# UNITED STATES PATENT AND TRADEMARK OFFICE

APPLICATION NO.	FILING DATE	FIRST NAMED INVENTOR	ATTORNEY DOCKET NO.	CONFIRMATION NO.
09/965,973	09/28/2001	Mark A. Freeman		5182
7590	09/09/2005		EXAMINER	
Mark A. Freeman 8928 Twilight Lenexa, KS 66219			HYLTON, ROBIN ANNETTE	
			ART UNIT	PAPER NUMBER
			3727	
			DATE MAILED: 09/09/2005

<b>Office Action Summary</b>	<b>Application No.</b>	<b>Applicant(s)</b>	
	09/965,973	FREEMAN ET AL.	
	<b>Examiner</b>	<b>Art Unit</b>	
	Robin A. Hylton	3727

## DETAILED ACTION

FIGURE 1

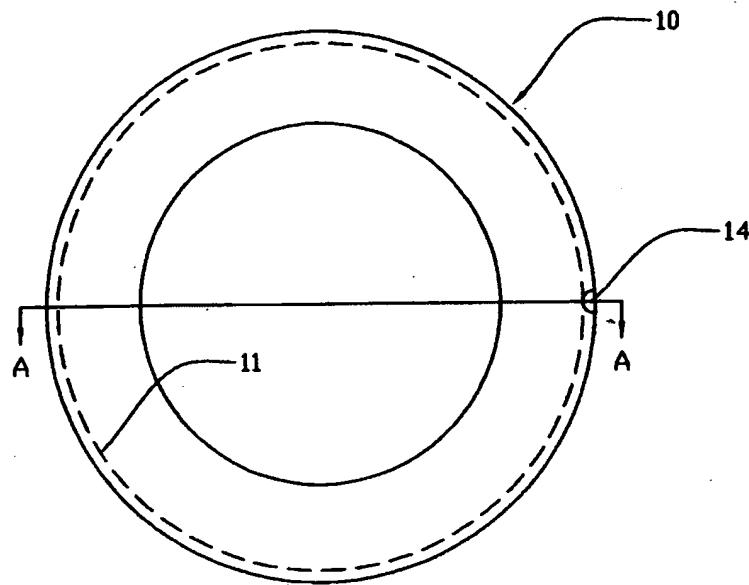
Replacement sheet containing Figures 1 and 1A is approved.

Approved  
for filing

FIGURE 1A'

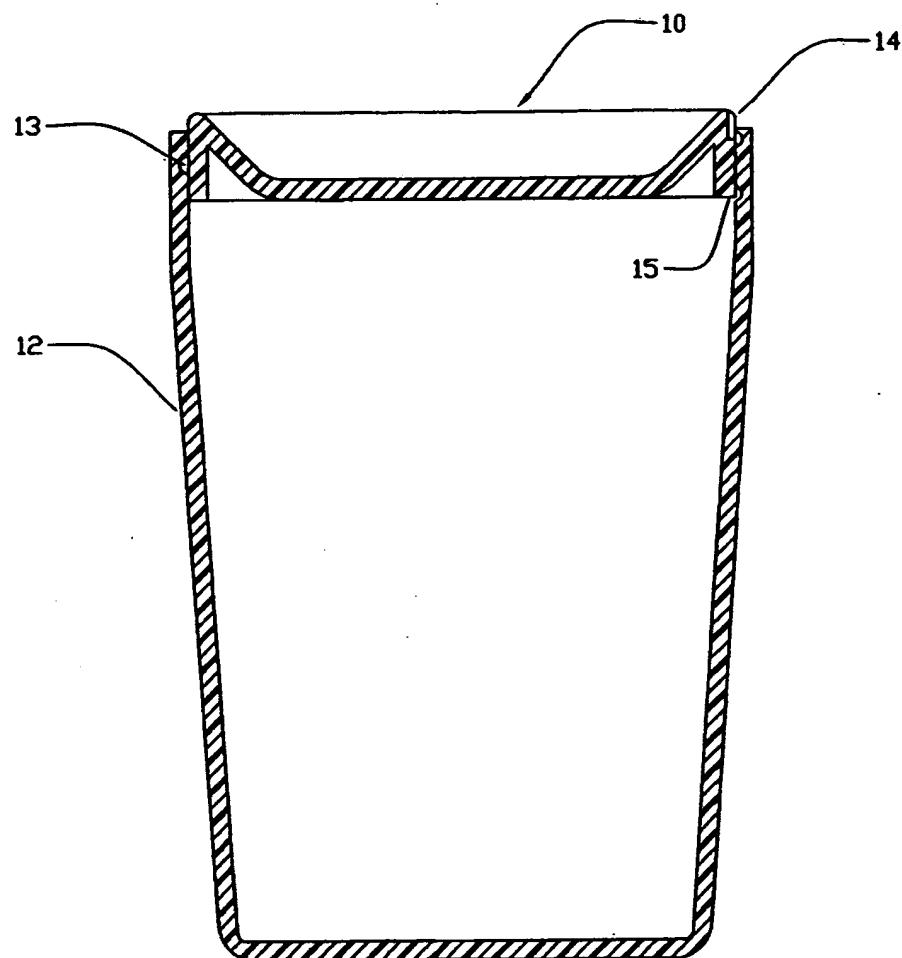
1. The drawings were received on June 15, 2005. These drawings are not approved since they introduce new matter. 37 CFR 1.121(9) states that no amendment may introduce new matter into the specification. Although the originally filed specification set forth the possibility of multiple recessed channels, there is no disclosure to support the channels as depicted in the new drawing sheets.

FIGURE 2B

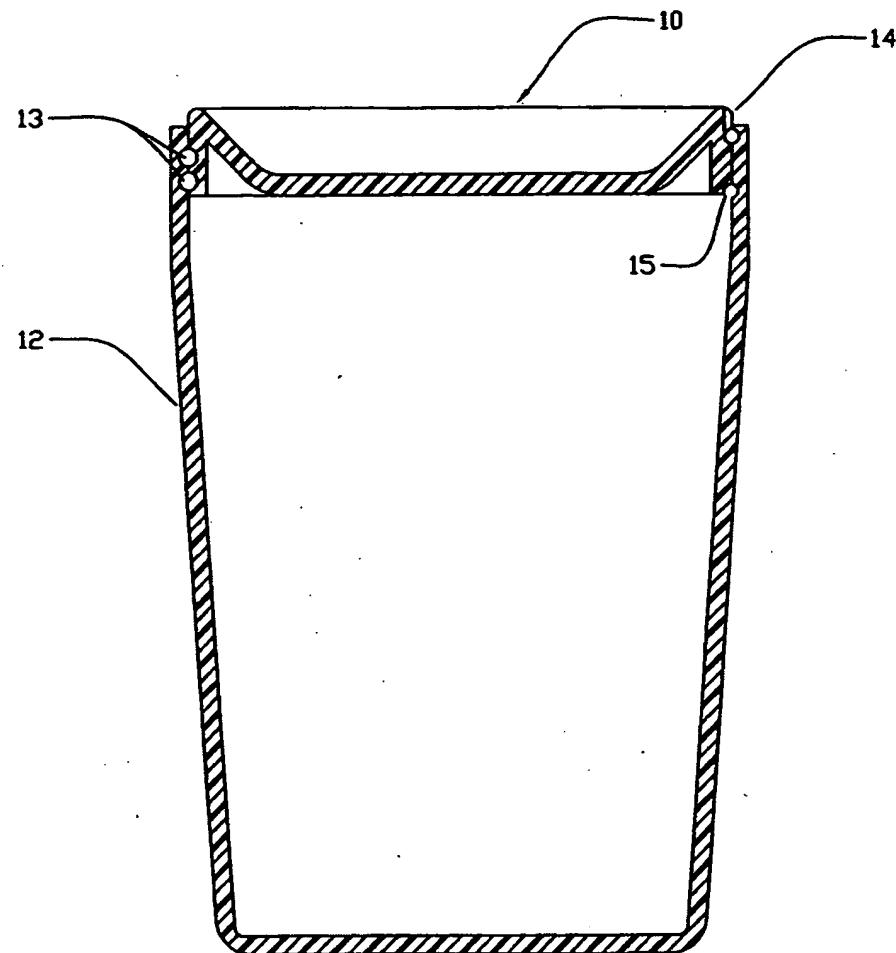
not appropriate
